APPLICATION FOR CONDITIONAL USE PERMIT

Case No. 87-67- CUP

NAME OF PROPOSED DEVELOPMENT Mr. M Addition

- IV. B. P&Z 87-PP/SP/CUP- Discuss and Consider Approval of a Conditional Use Permit for Gasoline Sales as an Accessory to a Retail Use and a Site Plan/Preliminary Plat for a Mr. M. Located on FM-740 and Horizon Road

4th Sub - Final Sub

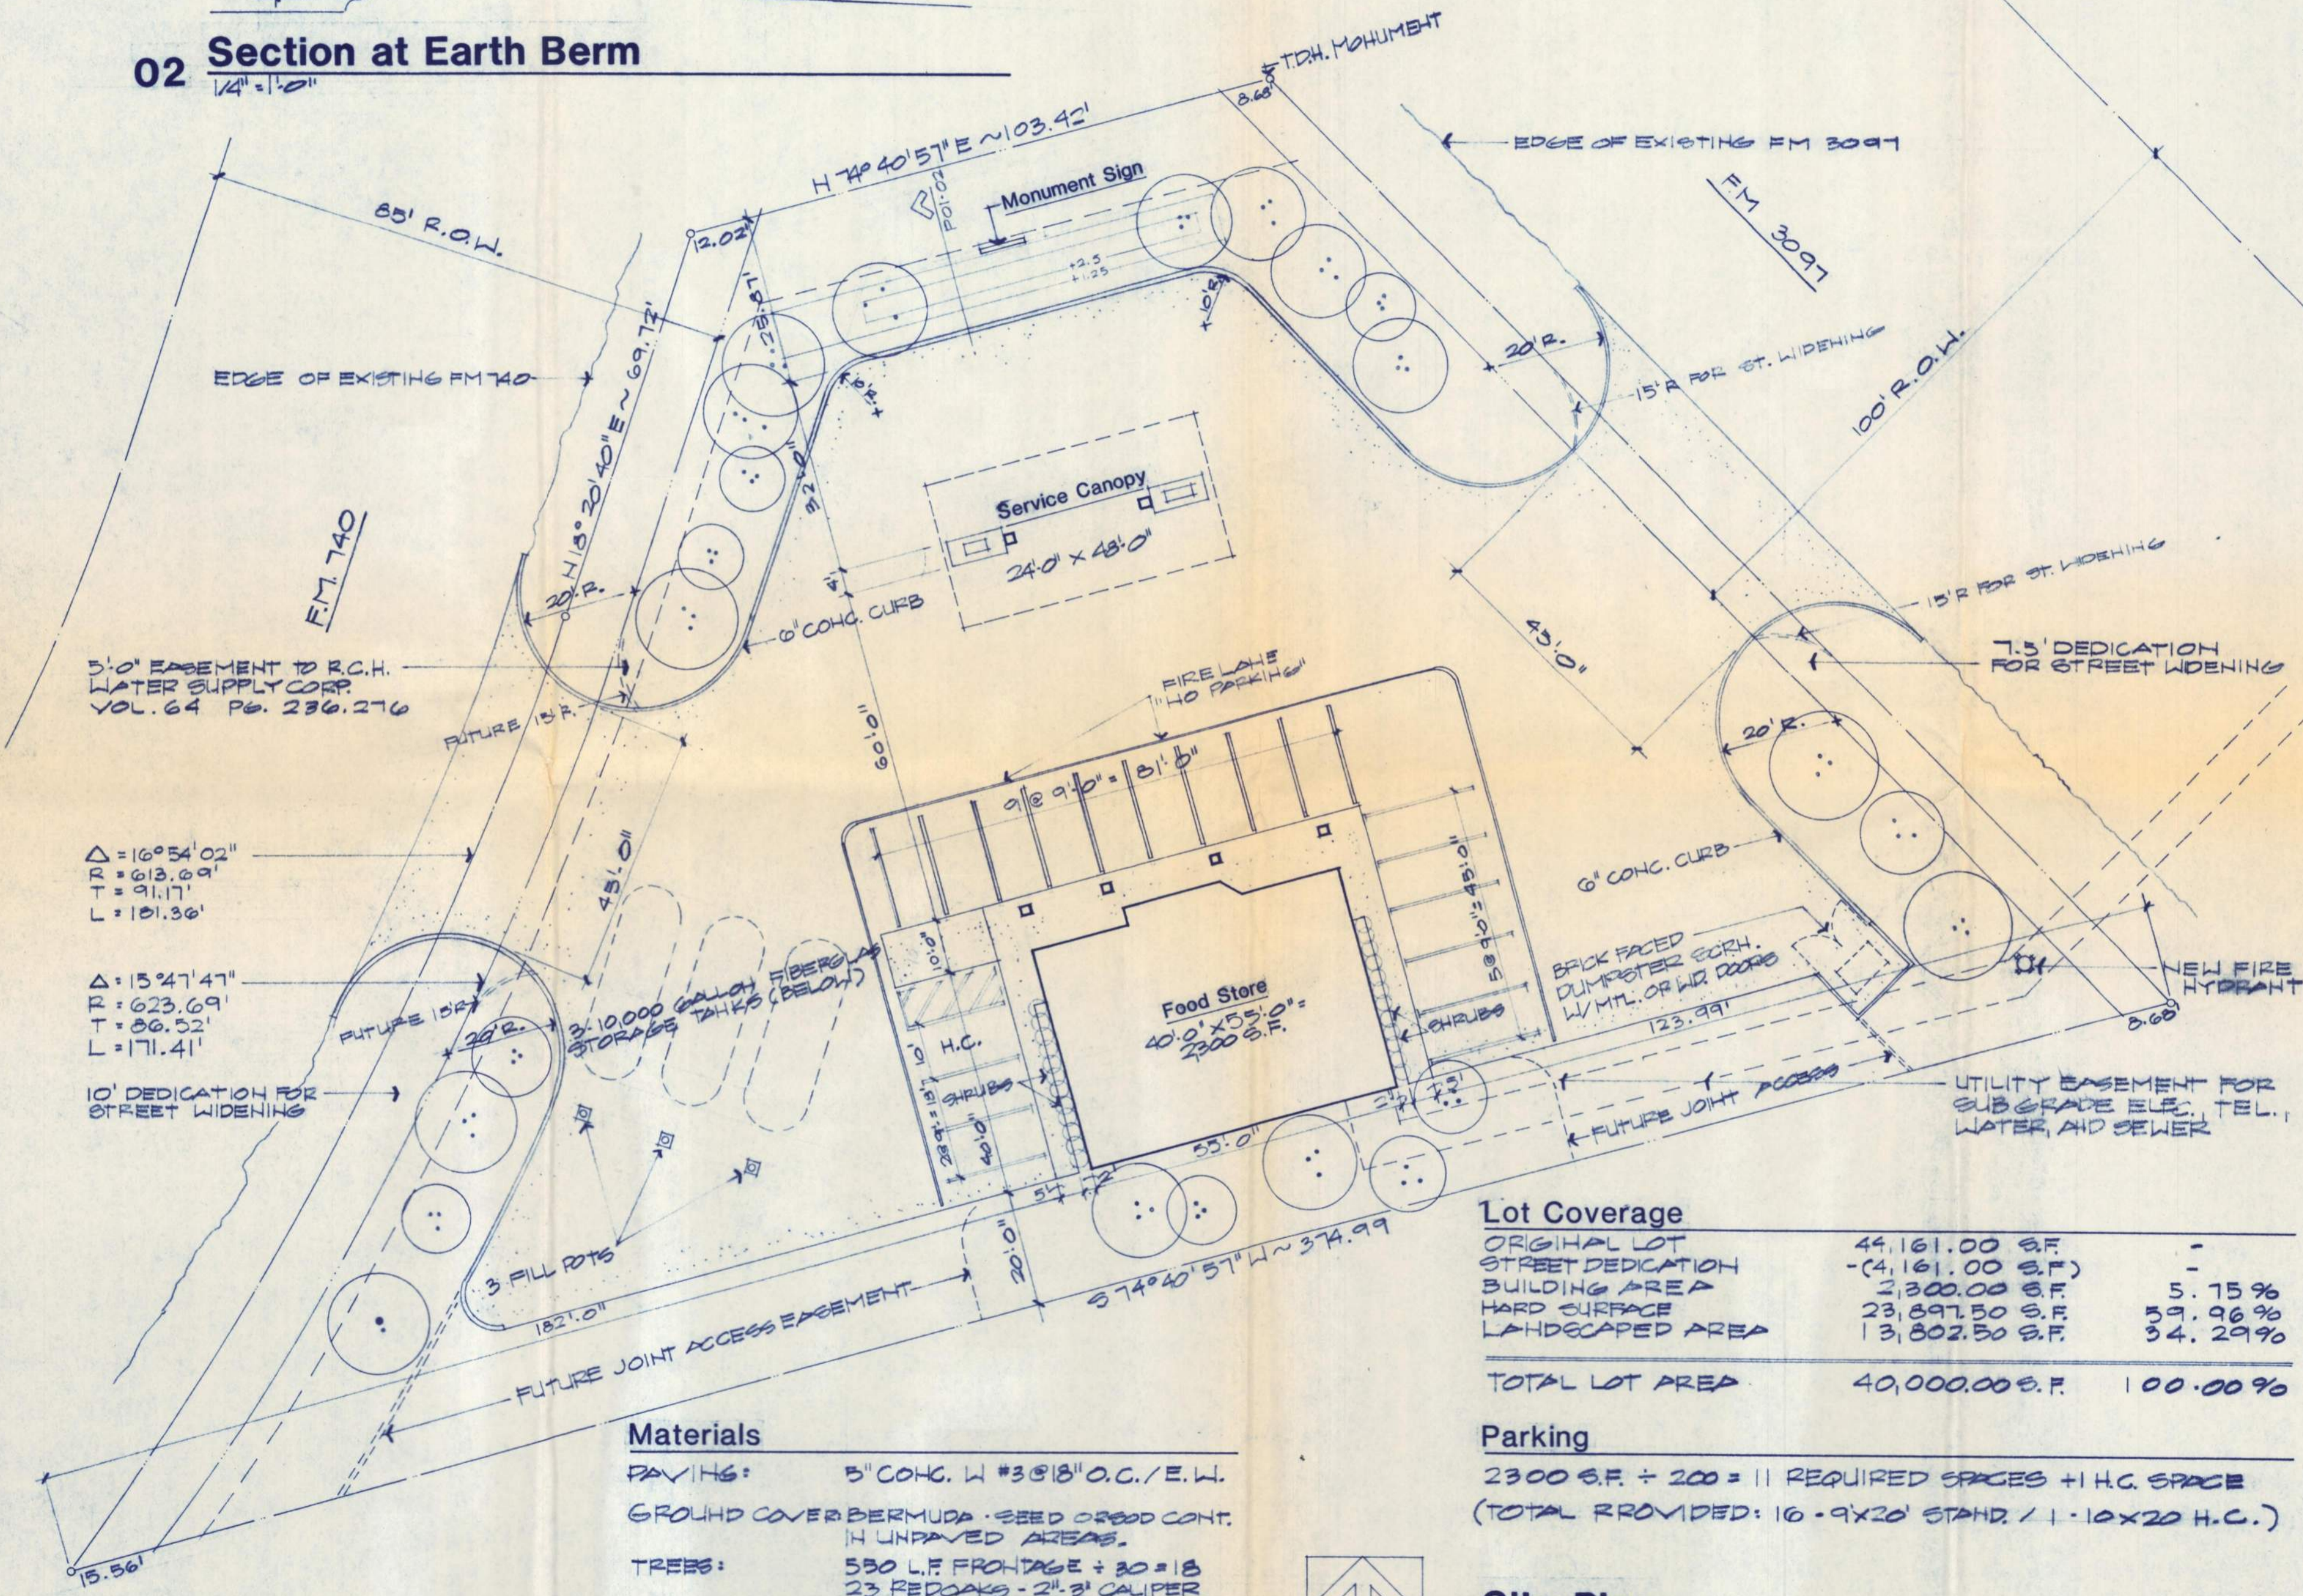
The plan initially indicated a dedication of 5 ft. of right-of-way on FM-740 and 7.5 ft. on FM-3097. We had preliminarily felt that 115 ft. of total ROW on 3097 and 90 ft. on 740 would accommodate the improvements contemplated in the Thoroughfare Plan. We requested our Traffic Planner, John Reglin, to review the plan and to review our future needs at this intersection which is going to ultimately be a very important intersection. After looking at the anticipated traffic volumes and making some assumptions about where the traffic is going to want to go, Mr. Reglin is recommending that we provide for the ability to install two left turn lanes onto Horizon Road. Because this will be the interchange closest to the lake, he believes most I-30 bound traffic going to Dallas will make this turn.

This configuration designed to State standards is going to require 100 ft. of ROW at the intersection for a distance of 500 ft. We have informed Mr. M and the developer of this additional requirement and they have made the appropriate changes. This will not have any impact on the site plan other than moving the landscaping in 5 ft.

- A. Consider moving the trash receptacle adjacent to the 20 foot landscape buffer, screened with a brick wall and planting, i.e., photinias and face the door to the building. This would more accurately meet the requirements of the District and would also, if it is faced at an angle, make access by a front loading trash truck easier.
- B. Consider some vertical planting along the back of the building such as photinias that require little maintenance but would provide a break in the rear wall of the building.
- C. Consider some requirements regarding the supports for the gas canopy. They are proposing the standard pole supports. Something similar to the brick treatment used by the Gulf Station that ties the canopy to the building might be more appropriate in the District.

- 1) move the proposed trash receptacle adjacent to 20 ft. landscaped buffer, screen with brick wall and planting facing toward the building
- 2) elevations to conform with photos shown of the Rowlett store including color of brick
- 3) the metal roof to be extended to all four sides of the building
- 4) property to rear of building to be landscaped with photinias
- 5) canopy support columns to be treated with brick
- 6) sidewalks on sides of building to be widened and landscaped with shrubbery adjacent to building.
